An Coimisiún Pleanála,
64 Marlborough Street,
Dublin 1,
D01 V902
Date: 21st April 2026.

Planning Application Reference Number 324132-26
An Coimisiún Pleanála - Case Reference: VA92.324132

Applicant Name: Marmoris Limited Trading as Killough Solar.

Description of Development: Proposed development of a 110kV GIS substation providing connection to the national grid via a loop in/ loop out connection to the already existing Killhill - Thurles 110kV Overhead line and ancillary development.

Plate 12-1: Cable Route and 110kV Substation Site

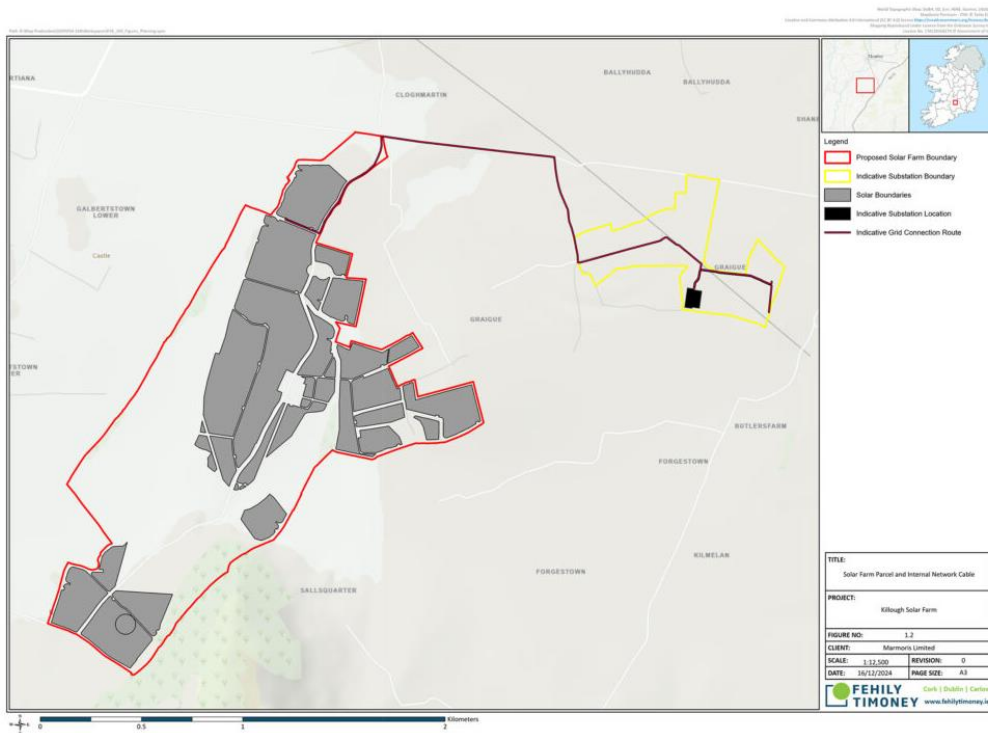
- It is concerning that Moycarkey village is not meaningfully addressed in the planning application, beyond a reference to the electoral district, despite the proposed substation being located within 390 metres of the village, and in close proximity to St Peter's Church.

- As can be seen from the images above at the time planning permission was granted for the solar farm, the substation was identified in a different location to that now proposed. The location appears to have moved approximately 300 metres closer to the village.

- There is no evidence in the application that genuinely alternative sites were assessed. The relocation appears limited to adjustments within the same landholding rather than a comparative site selection process.

Figure 13-1: Viewpoint location map (showing viewing extents and direction of view)

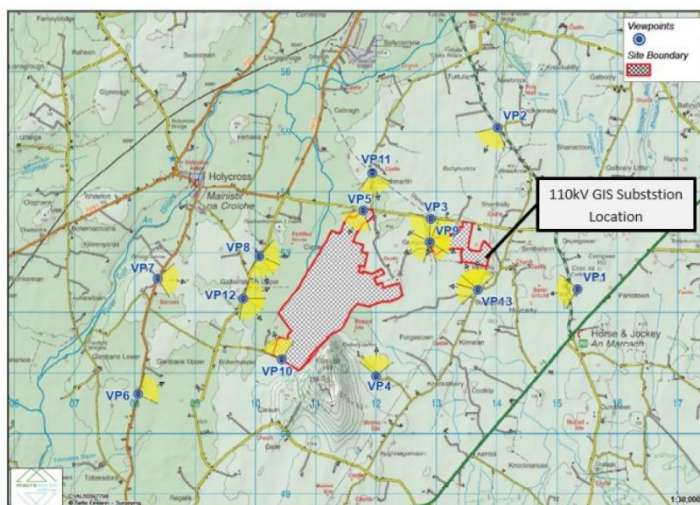
Although the planning application contains a Visual Impact Assessment with photomontages, it notably omits viewpoints from the village of Moycarkey and residential properties most directly impacted by the proposed substation. This represents a significant deficiency, as it fails to accurately assess the true visual impact of residents in the village.

- No visual impact assessment has been provided from Moycarkey village or from the approach roads leading to the village, where there are direct lines of sight to the proposed substation site.

PHOTO 01

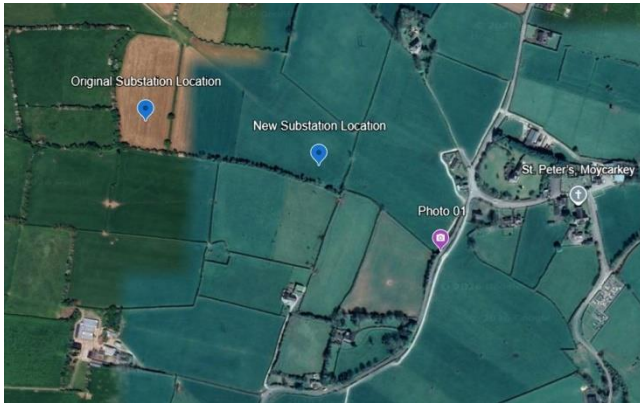
Photos below represent the views we believe were omitted.
